Project # A1322-02 NJDOT Headquarters Solar PPA

Bulletin C

PROJECT#: **A1322-02 NJDOT Headquarters Solar PPA**

BULLETIN C

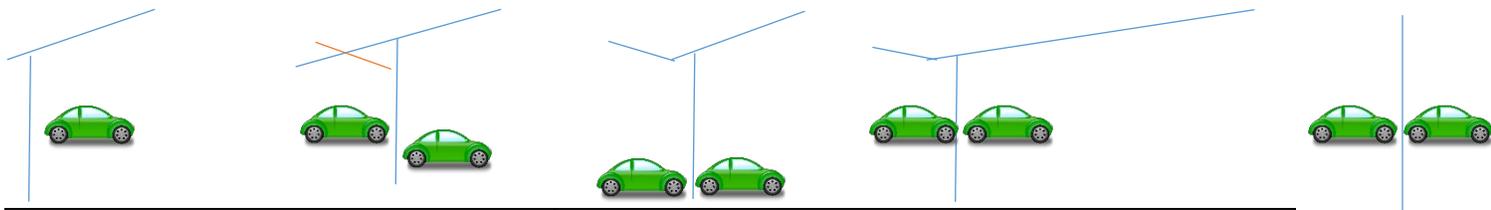
- 2) Based on these meter descriptions could you tell me what meters align with consumption and location

Meter Consumption (kWh)	DC Size estimated on 1200 yield (kW)	Meter Description	Number on plans
18877	15.7	Adjacent to sidewalk on lower ferry road - skinny enclosure with disconnect	
24875	20.7	Silver Box in front of MOB parking along sidewalk	
3893681	3244.7	Basement of E&O, South Wall in HVEPR	
2430365	2025.3	Bldg 22 - small bldg next to 19 on south wall in southeast corner	
82720	68.9	South Side of Modular building behind Thiokol	
101160	84.3	South Wall exterior in little room with no door	
1875794	1563.2	electric shed outside building 2 Thiokol south entrance	
21720	18.1	Southwest corner of building exterior	
820	0.7	interior rear south wall of building	
3436	2.9	yellow shack by railroad beside DOT	
10630	8.9	North side fence behind DOT

Response: Please refer to the Bulletin C - Attachment 1 revised E101 drawing from Gannett Fleming.
